Access Compliance Report

Public Rights-of-Way

(Curb Ramps)

Intersection ID: 17450	Main Street: NATIONS_FORD_RD	Cross Street: S_TRYON_ST	Location: NW
ADA ID: B7D0E3A94A4B	Ramp Type: PerpDiag	Initial Pass/Fail: Fail	Overall Compliance: No
		Severity Score: 37.5

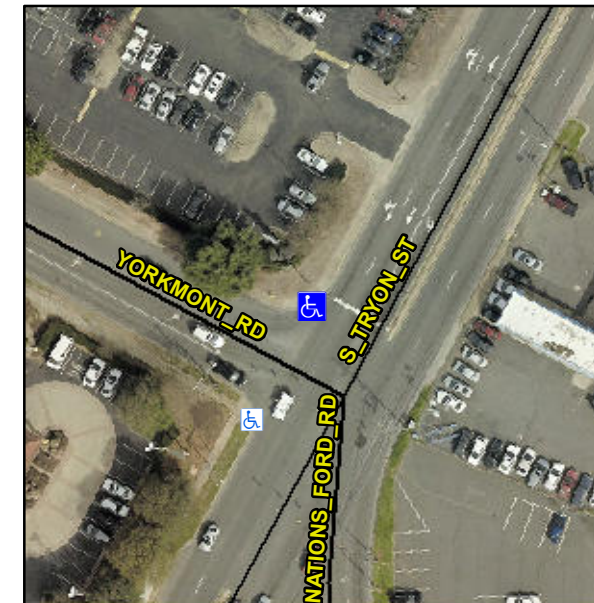
Not Found, R304.2.2, R304.5.3

Compliance	Description	Data	Compliance	Description	Data
N/A	Ramp Length (in)	56.0	No	Ramp Slope (%)	8.9
Yes	Ramp Width (in)	48.0	No	Ramp XSlope (%)	8.6
N/A	Flare Type LT	N/A	N/A	Flare Type RT	N/A
N/A	Flare Slope LT (%)	N/A	N/A	Flare Slope RT (%)	N/A
N/A	Flare Traversable LT?	N/A	N/A	Flare Traversable RT?	N/A
N/A	Landing Length (in)	N/A	N/A	DWS Provided?	N/A
N/A	Landing Width (in)	N/A	N/A	DWS Contrast?	N/A
N/A	Landing Slope (%)	N/A	N/A	DWS Length (in)	N/A
N/A	Landing X Slope (%)	N/A	N/A	DWS Full Width?	N/A
N/A	Landing Curb? (Y/N)	N/A	N/A	DWS Offset (in)	N/A
N/A	Shared Landing?	N/A			
N/A	Gutter Ponding?	N/A	N/A	Gutter Slope (%)	N/A
N/A	Gutter Lip Ht (in)	N/A	N/A	Gutter X Slope (%)	N/A
N/A	Painted X Walk1?	No	N/A	Painted X Walk2?	No
	X Walk 1 Direction	To SW		X Walk 2 Direction	To SE
N/A	X Walk 1 Width (in)	N/A	N/A	X Walk 2 Width (in)	N/A
	X Walk 1 Slope (%)	3.2		X Walk 2 Slope (%)	0.7
	X Walk 1 X Slope (%)	2.7		X Walk 2 X Slope (%)	0.2

Remove & Replace Curb Ramp With Two New Directional Ramps or Equivalent.
